CADIZ GROUNDWATER STORAGE AND DRY-YEAR SUPPLY PROGRAM

Final Environmental Impact Report
Final Environmental Impact Statement
Public Participation and Response to
Comments on the Draft EIR/EIS
Volume II
SCH. No. 99021039

FINAL ENVIRONMENTAL IMPACT REPORT FINAL ENVIRONMENTAL IMPACT STATEMENT CADIZ GROUNDWATER STORAGE AND DRY-YEAR SUPPLY PROGRAM SAN BERNARDINO COUNTY, CALIFORNIA

Figure 1.--Delta oxygen-18 and delta deuterium data from Fenner Valley and vicinity

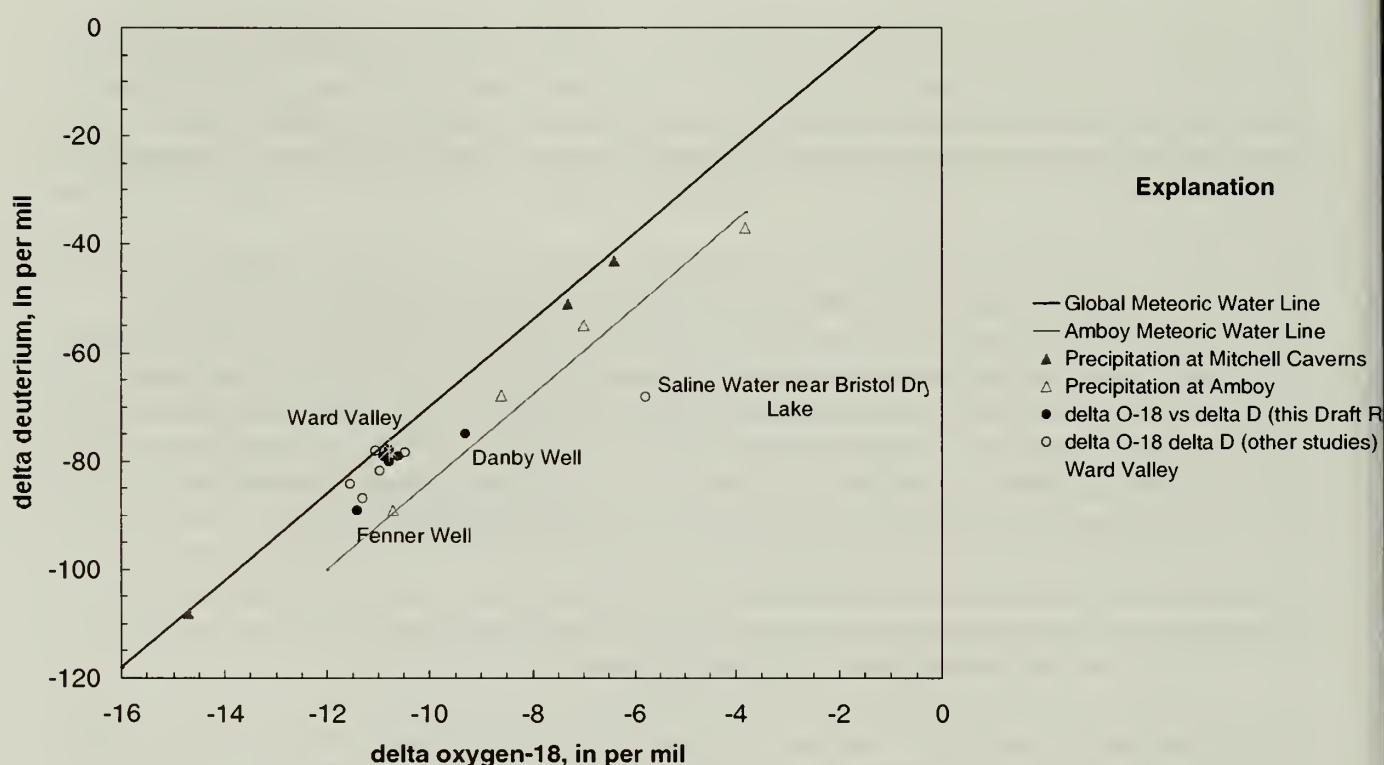
Comments on interpretation of oxygen-18 and deuterium data--The δD and $\delta^{18}O$ isotopic compositions of precipitation collected by Friedman et al. (1992) at Mitchell Caverns and at Amboy (near Bristol dry lake and closer to the study site) are different. Data from Mitchell Caverns plots on the meteoric water line. Data from Amboy plot on a line parallel to, but below, the meteoric water line. The isotopic composition of precipitation data at Amboy relative to the

meteoric water line is typical of precipitation in summer-dominated precipitation regimes of the Mojave Desert and across much of the arid southwestern United States. The isotopic composition of water from Mitchell Caverns is typical of water from cooler, higher altitude sites. The similarity in isotopic composition (both in absolute magnitude and position relative to the meteoric water line) of ground water sampled as part of the Draft Report in the Fenner Gap areas to precipitation at Mitchell Caverns suggests that the ground water originated as recharge from precipitation that fell at a higher altitude rather than from locally derived precipitation. This is consistent with the interpretation presented in the Draft Report and is not consistent with infiltration from Schulyer Wash. Mitchell Caverns and other higher altitude locations are many miles from the study site and ground-water flow paths through alluvial aquifers are long.

Water from the Danby well (this Draft Report) plots below the meteoric water line along the local meteoric water line at Amboy. Its position along the Amboy meteoric water line suggests a locally derived origin for water from this well. This is consistent with the interpretation presented in the Draft Report and the δD and $\delta^{18}O$ composition of water from the Danby well is cited as evidence of infiltration from washes that drain Fenner Valley. However, if infiltration is occurring along the wash, why is there no isotopic or chemical evidence of water from this source in the Fenner Gap wells? Similarly, data from an upgradient well along the wash at Essex (LaMoreaux & Associates, 1995) show no evidence of infiltration from the wash. Friewald

FIGURE 6--MODEL 1 PRECIPITATION FOR THE CADIZ PROJECT STUDY AREA

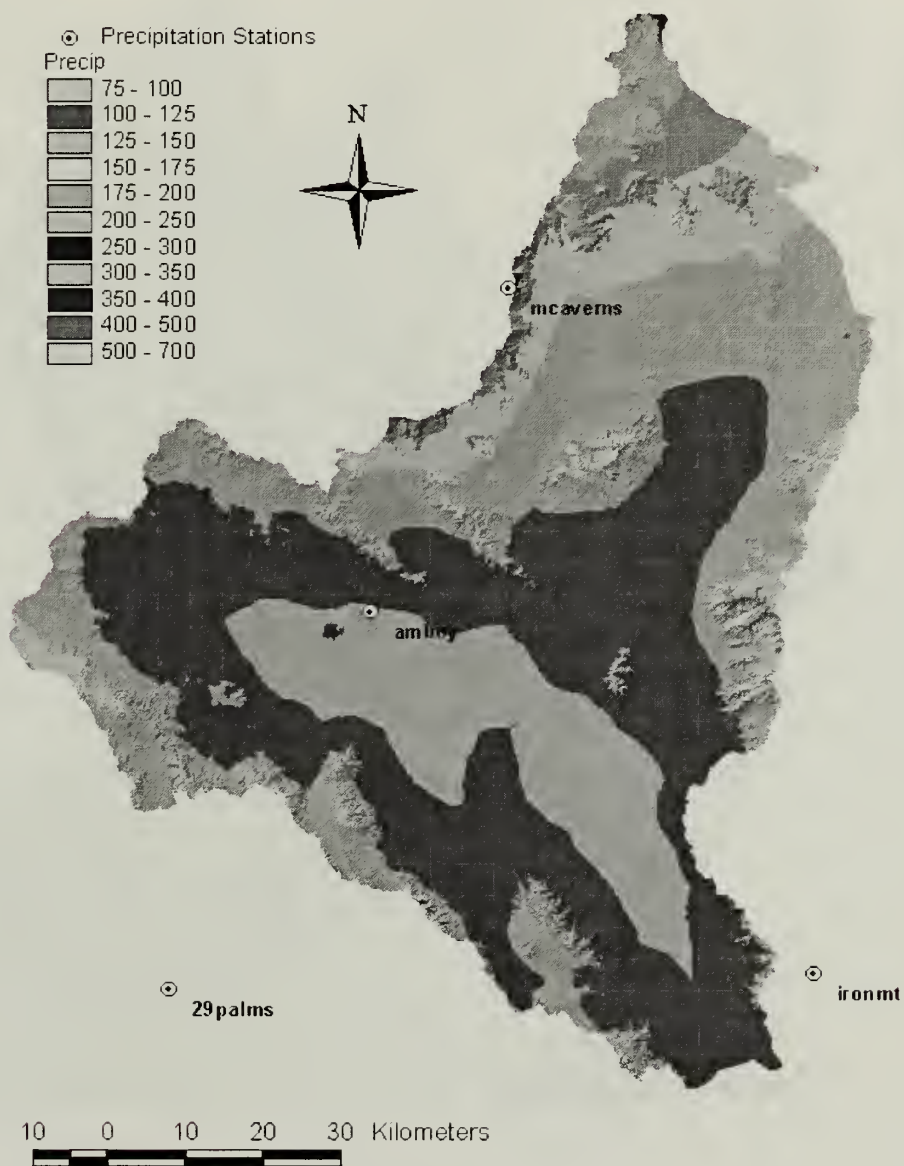
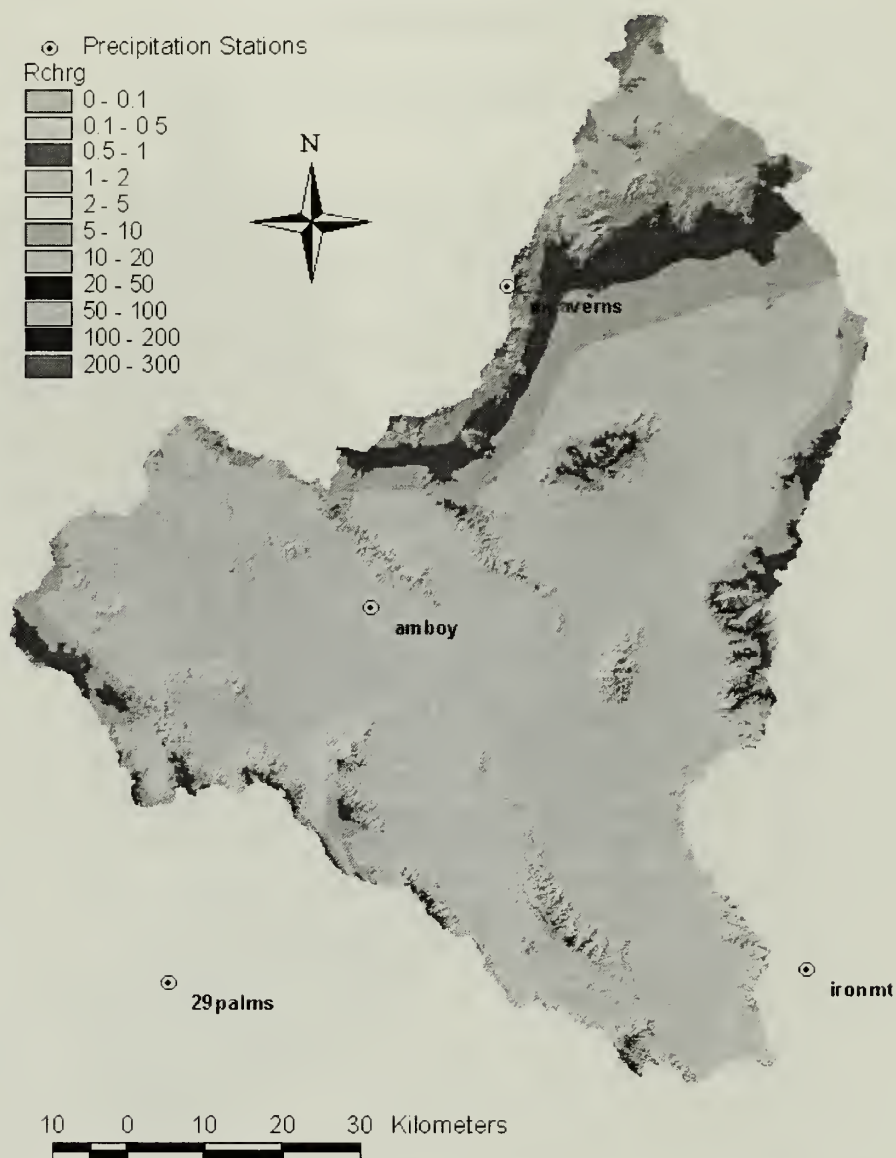
Figure 6 shows the spatial distribution of the preliminary USGS estimates of average annual precipitation using model 1 for the Fenner, Bristol, and Cadiz watersheds. Figure 7 shows the spatial distribution of the preliminary USGS estimates of average annual recharge for the watersheds obtained using the modified Maxey-Eakin model and the estimated average annual precipitation map. The spatial distribution of recharge rates as high as 10 to 20 millimeters per year for the higher elevation locations of the New York Mountains and the Providence Range within the Cadiz Project study area are considered reasonable in comparison to recharge estimates obtained throughout the Mojave Desert region in southeastern California and southern Nevada. For example, recharge has been estimated to be approximately 20 millimeters per year (0.79 inch per year) at elevations of approximately 2,200 meters (7,218 feet) in the northern part of the Nevada Test Site based on measurements of seepage in underground tunnels. The recharge rates of 10 to

FIGURE 9--MODEL 1 EXPANDED AREA ELEVATION

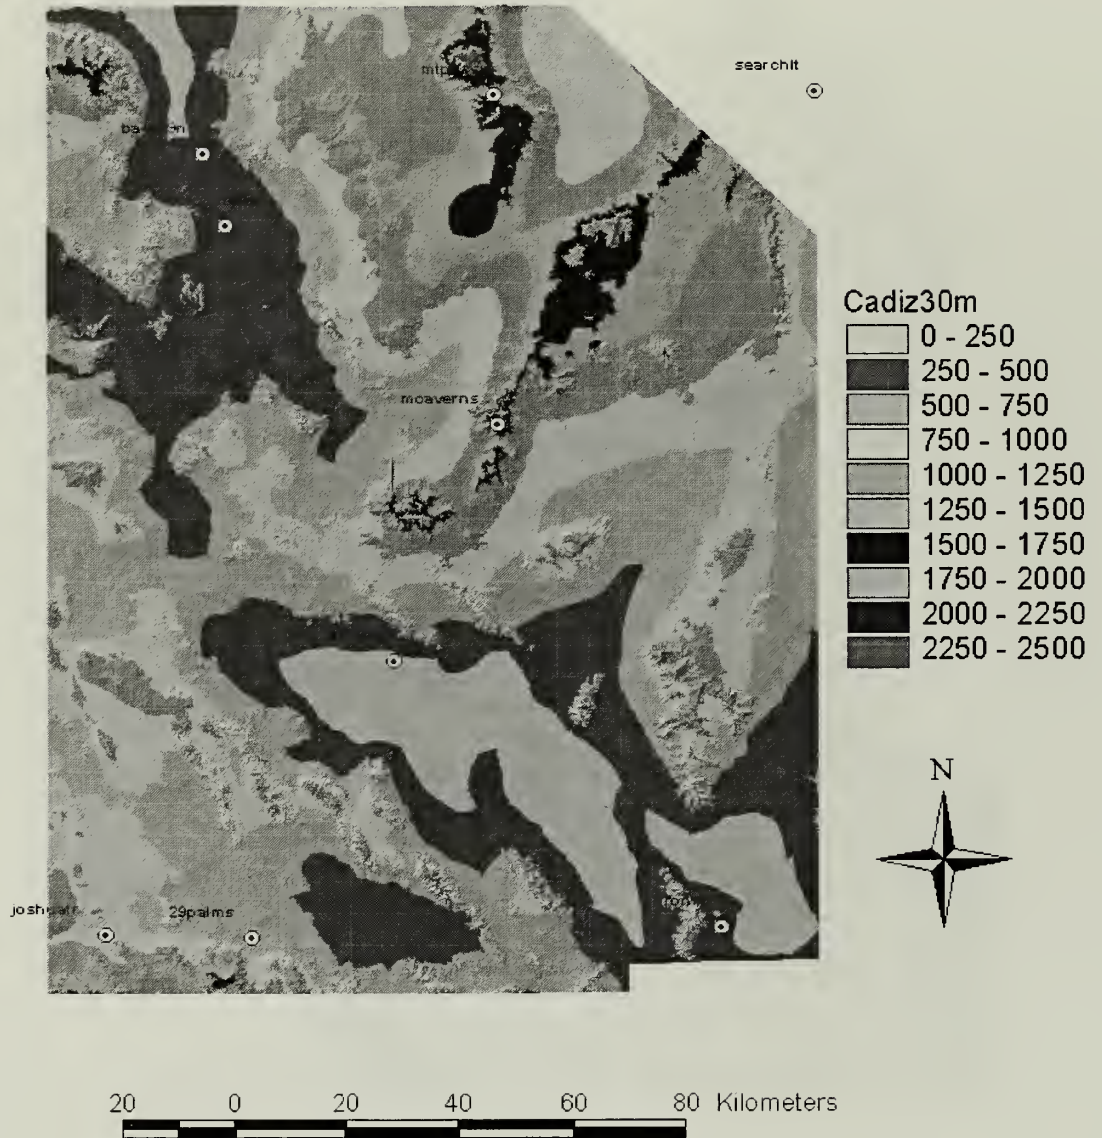
Preliminary recharge estimates were also obtained for an expanded study area including parts of basins adjacent to Fenner, Bristol, and Cadiz watersheds (figure 9). Although the assumption that surface-water and ground-water divides are equivalent is reasonable, a possibility exists that interbasin transfer of ground water through carbonate aquifers (or some other permeable structure or unit) provides inflow to the Cadiz Project watersheds. The total area contributed to ground-water recharge for the Cadiz project as represented by the expanded study area is considered to be highly unlikely as a true contributing area, especially since much of the area included in the northeastern part of the expanded area drains toward Ivanpah and Soda Lakes (dry). The intent of developing recharge estimates for the expanded area is to provide a comparison with the estimated recharge volumes presented in the Draft Report. The total estimated recharge volume for the expanded area is assumed to be greater than the actual recharge volumes available for the Cadiz project. The spatial distribution of the model 1 preliminary precipitation estimates for the expanded study area is provided in figure 10, and the recharge estimates for the expanded area is provided in figure 11. These results were considered reasonable in comparison to recharge studies conducted throughout the southern Great Basin.

FIGURE 12--MODEL 2 ESTIMATED PRECIPITATION FOR CADIZ PROJECT STUDY AREA

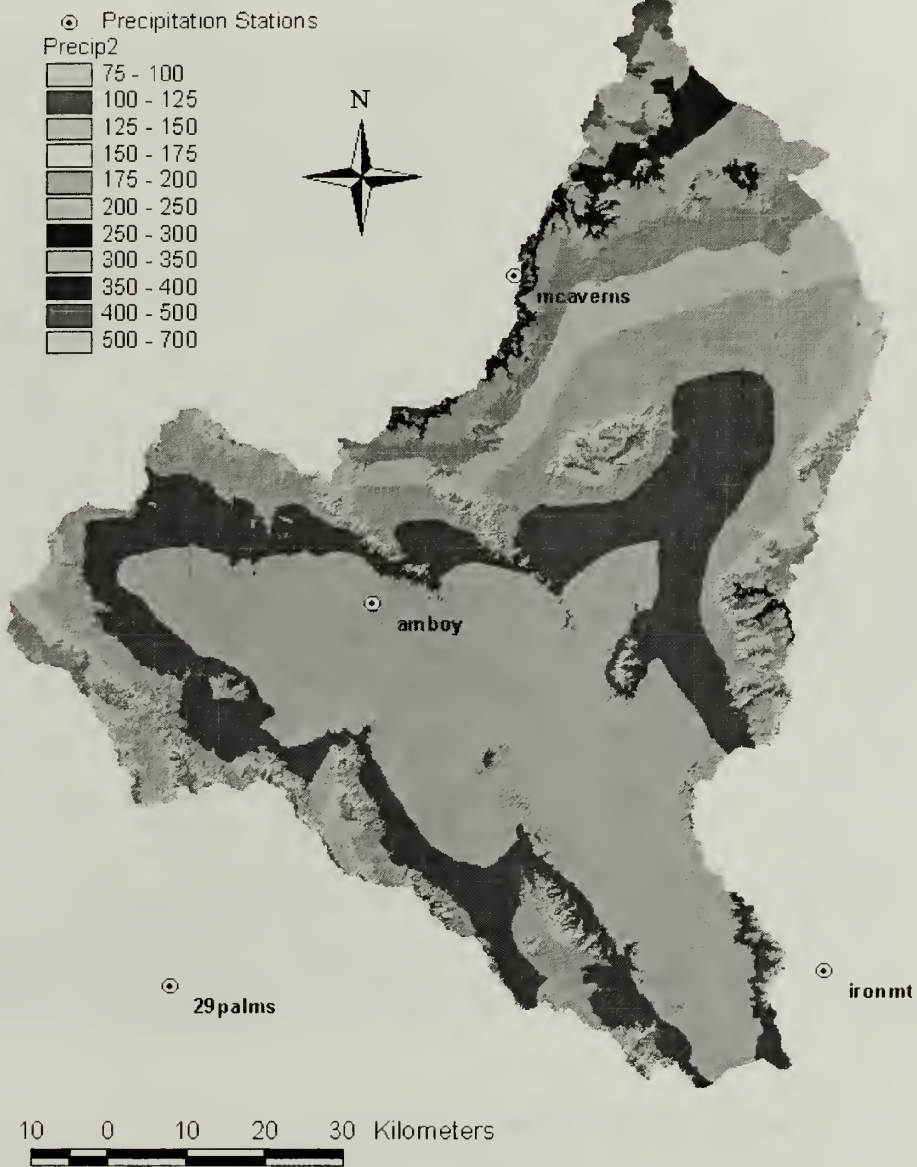
Figure 12 shows the spatial distribution of the preliminary estimates of average annual precipitation using model 2 for the Fenner, Bristol, and Cadiz watersheds. Although this model provided a better fit to the precipitation records for the four Cadiz area precipitation stations, precipitation estimates of as high as 517 to 625 millimeters per year (2.3 to 24.6 inches per year) were obtained for elevations of approximately 1,800 meters (5,906 feet) and higher in the Providence and New York Mountains. These estimates are considered to be too high on the basis of a comparison with locations having similar amounts of precipitation but which are at much higher elevations, such as South Lake at an elevation of 2,920 meters (9,580 feet) in the southeastern Sierra Nevada and Lee Canyon at an elevation of approximately 2,800 meters (9,187 feet) in the Spring Mountains of southern Nevada. Model 2 recharge estimates are as high as 100 millimeters per year (3.9 inches per year) in the New York Mountains (figure 13), which is considered to be unreasonably high for this location on the basis of a comparison with estimated recharge rates of approximately 20 millimeters per year (0.79 inches per year)

SCENARIO 5 (AVERAGE) MAXIMUM DRAWDOWN (YEAR 34)

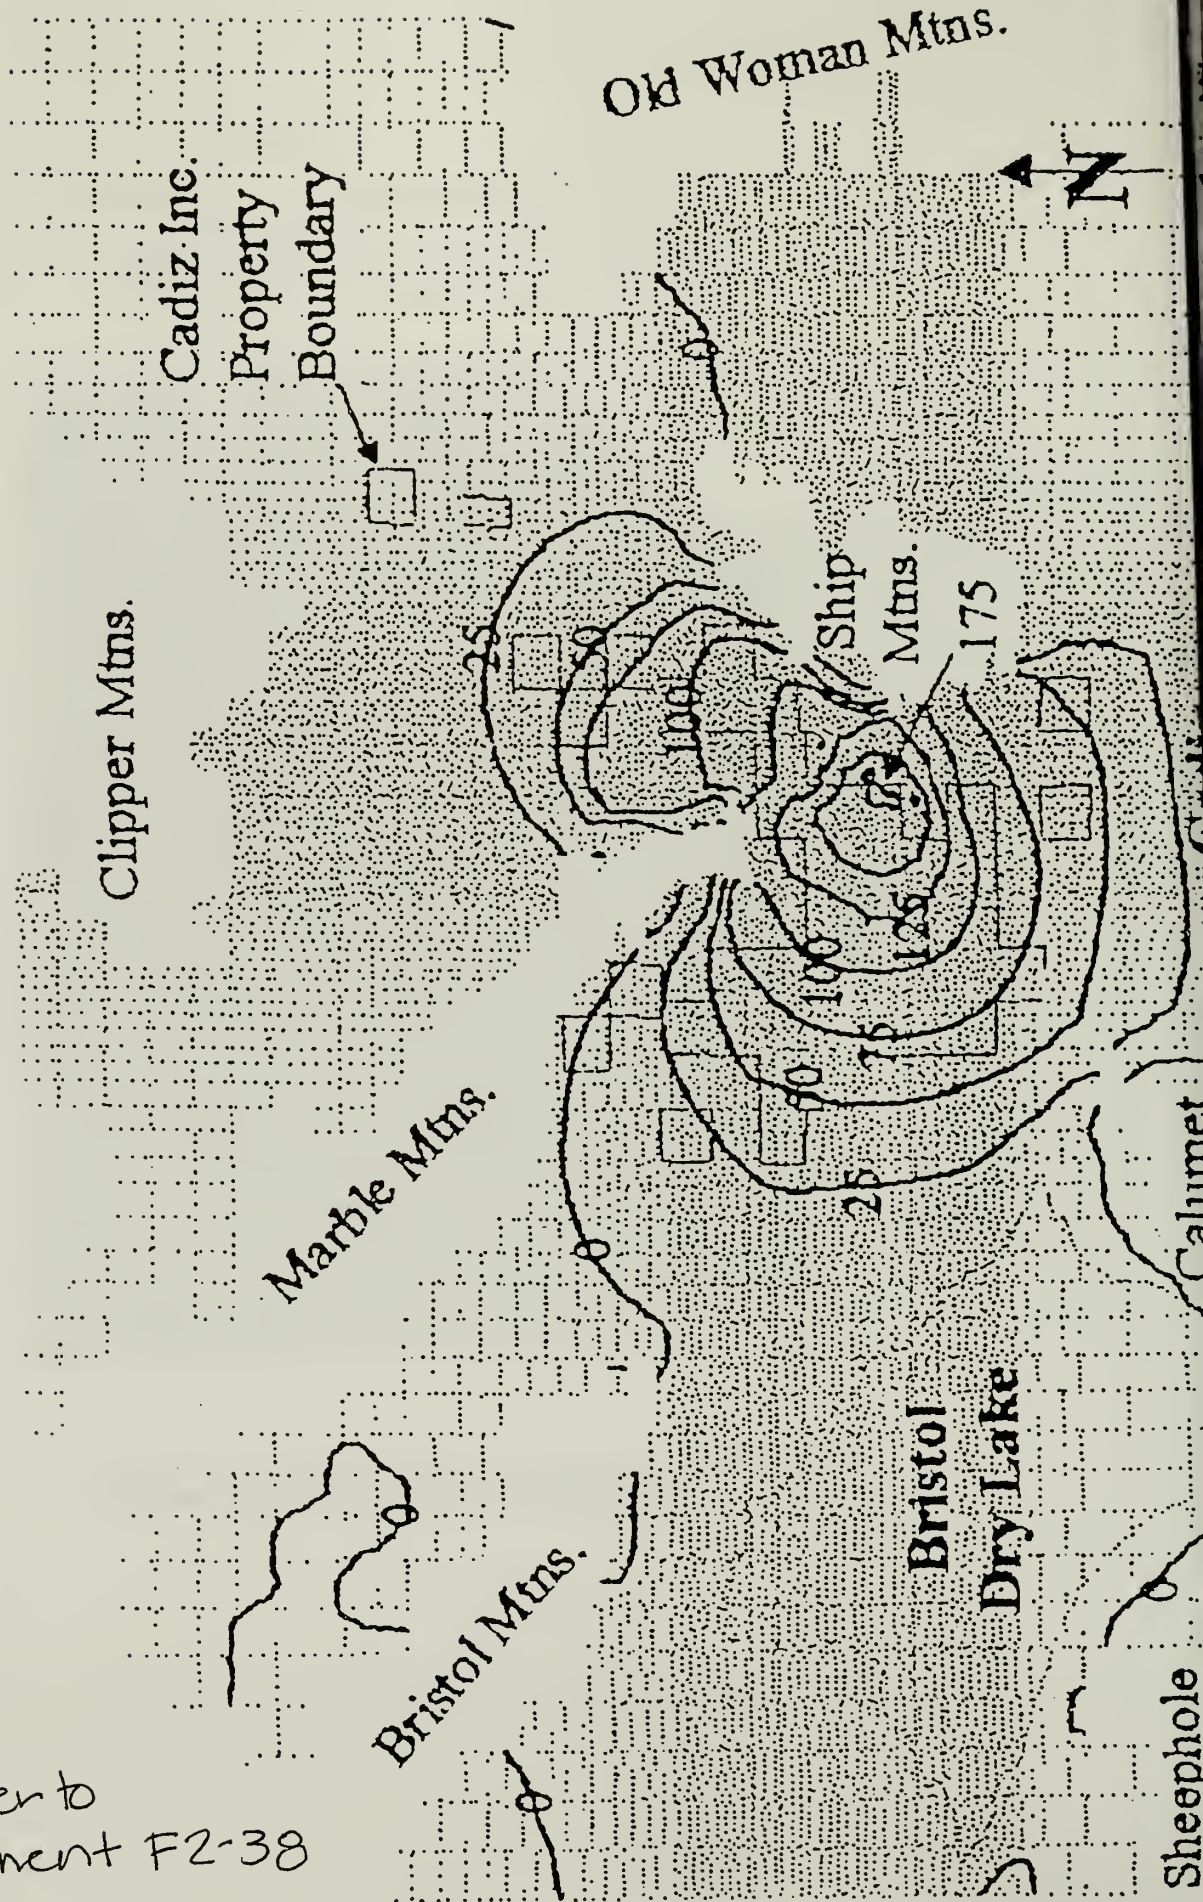
Prefer
to comment
F2-38
